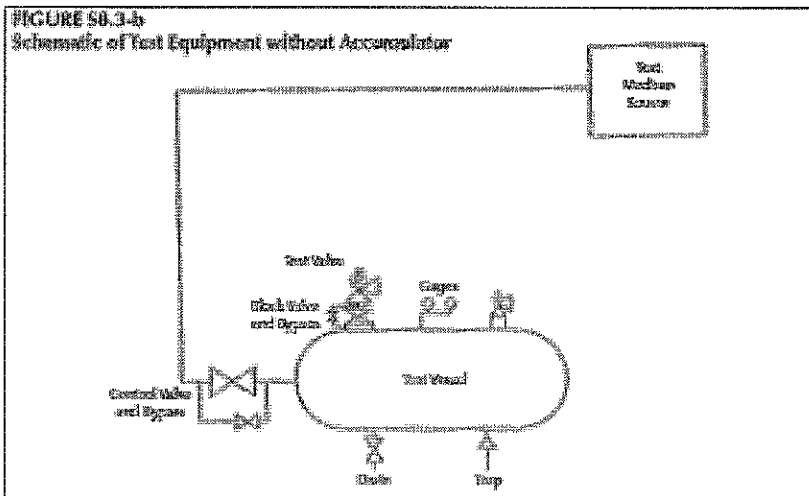
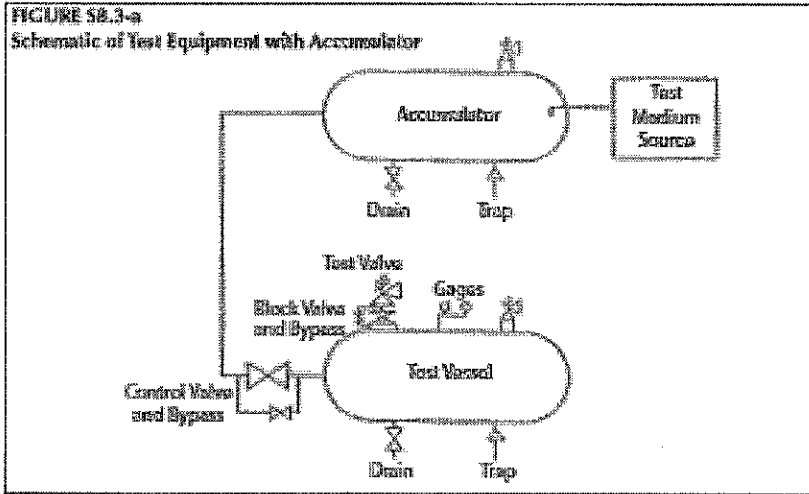
- a) An optimum configuration, particularly when the test medium source is of small capacity, is shown in Figure S8.3-a. The test medium flows from the pressure source, usually a compressor or boiler, to an accumulator. It then flows through a pressure-controlling valve into the test vessel, from which it is discharged, through the pressure relief valve installed mounted on the test vessel. The pressure-controlling valve is usually a globe valve, although any throttling valve is acceptable. If the pressure-controlling valve is of adequate size and can open quickly, large transient flows can be generated, increasing the pressure above the pressure relief valve set pressure, causing it to lift, and be sustained in its lifted condition.

- b) Figure S8.3-b shows a simpler test system in which the test vessel is pressurized directly from the pressure source without the use of an accumulator. In this configuration, flow-rates through the pressure relief valve and any consequent over-pressure are dependent on the flow generating capacity of the pressure source.

Figure 1

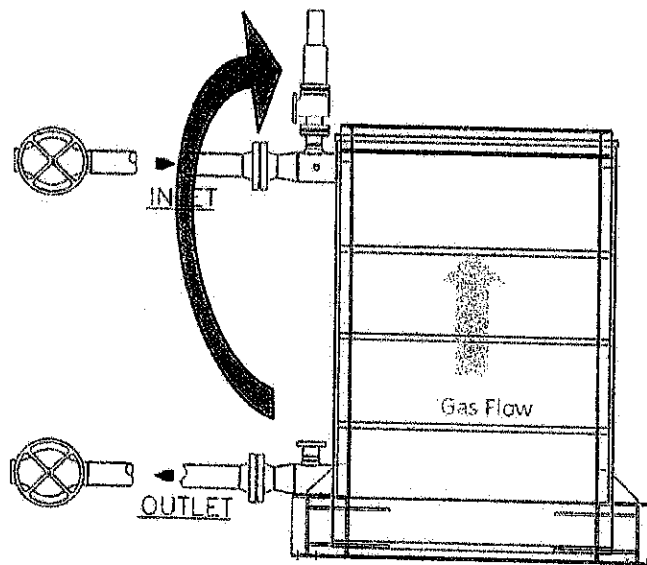
An example would be a vertical counterflow economizer where the inlet header is located above the outlet (as in Figure 1) if the designer can specify where the PSV be located then the PSV may be placed such that the release of energy, via steam, happens more slowly through the same size PSV.

Figure 1 illustrates a counter-flow economizer, in a vertical up gas path, having horizontal headers, with the outlet header below the inlet. When this type of economizer is isolated during operation, and the PSV is tripped, steam will begin to collect in the upper "inlet" header. This design allows a more controlled venting of isolatable economizers by venting steam instead of hot water. Figure 1 also illustrates moving the safety relief valve from the outlet to the preferred location.
